Date of Issue: May, 1947

**Service Information Sheet No. 67****SPEEDOMETER CABLES**

VIEW SHOWING SPEEDOMETER FLEXIBLE  
CABLE RUN BETWEEN FOOT RAMP AND  
CLUTCH HOUSING

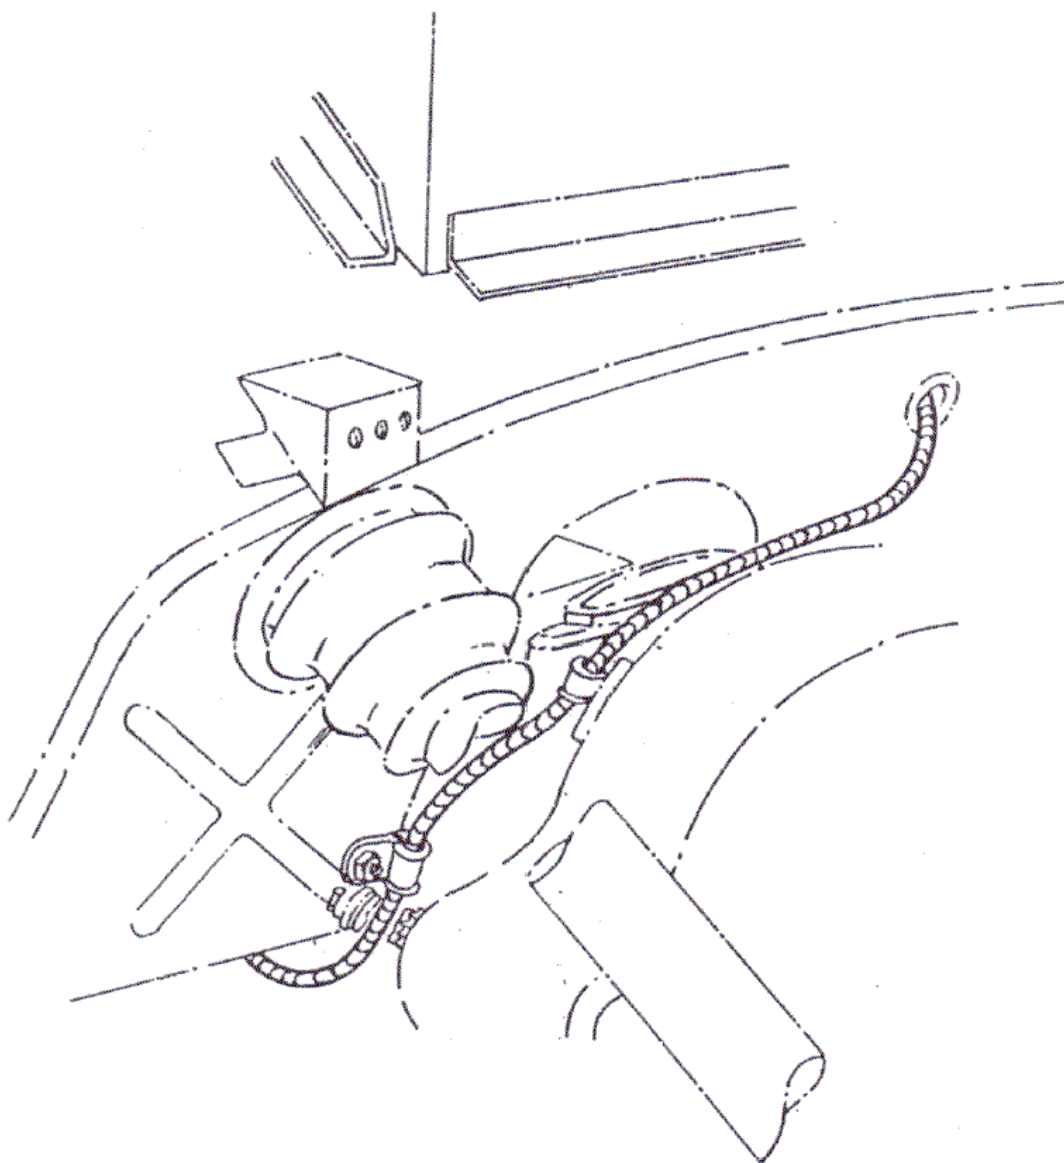
Complaints have been received of broken speedometer flexible cables, and oil finding its way up the cable and on to the numerals of the trip.

To obviate this, and commencing at Chassis No. TC.2196, a new cable, Pt. No. A.1270, Jaeger No. 245, is being fitted. Cables incorporated on chassis prior to the one quoted may be changed for the new type if desired.

The run of the cable has also been modified, and from the drive it will now pass under the gearbox a fair radius to clear the exhaust pipe and up the off-side, being clipped to the underside of the foot-plate, and running over the clutch housing, clipped to the clutch housing bolt, and through existing hole in grommet, as shown in sketch overleaf. The clip on the clutch housing should be twisted to maintain the curve of the flex over the housing.
